Board of Park Commissioners Change Order Approval Form

Franke Park Renaissance Phase I Design Change Order #2
Project: 221007 PO Number: 21121168

CHANGE ORDER NO. 2 - Project # 221007

Subject: Franke Park Renaissance – Phase I
Bridge Abutment Redesign Services

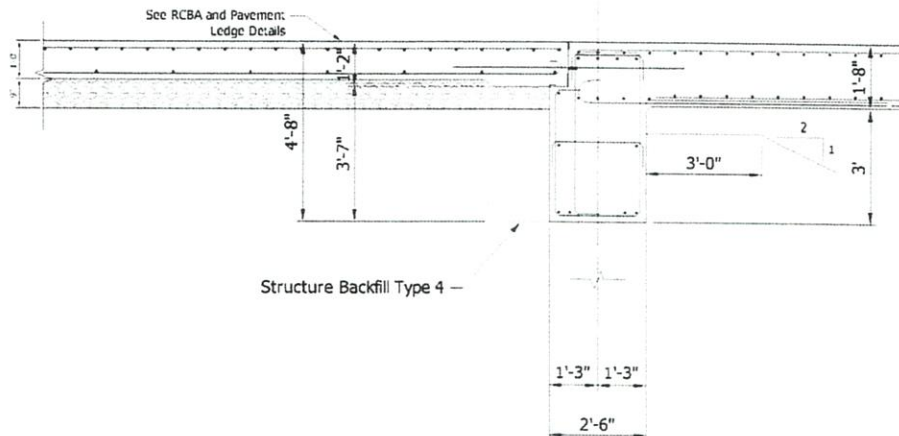
In accordance with our conversations, we are submitting this summary of the impacts to the project related to revising the bridge abutment design. The revision includes eliminating the bridge abutment as a retaining wall system with wingwalls and replacing it with an integral end bent with a spill slope. The abutment wall provides a larger waterway area as well as more distance for the mountain bike paths and pedestrian trail under the end spans.

With the spill slope, there will be approximately 14 feet from the toe of slope to the bridge pier, but a few feet of this includes riprap around the pier. On the north side, there will be over 18 feet from the toe of slope to the pier for the pedestrian trail. The images below provide a cross section of the currently proposed abutment wall and the proposed revision using the end bent and spill slope.

The end bent is significantly smaller than the abutment wall structure. We discussed the superstructure forming requirements, with a bridge contractor, since the forms would not be able to bear on the abutment foundation. To accommodate the poor soils, we intend to include another row of permanent piling approximately 10 feet away from the end bent. This has been included in the construction cost estimate. This method requires less removal of the surcharge soil used to consolidate the poor soils. It also requires less piling, reinforcing steel, concrete and engineered backfill.
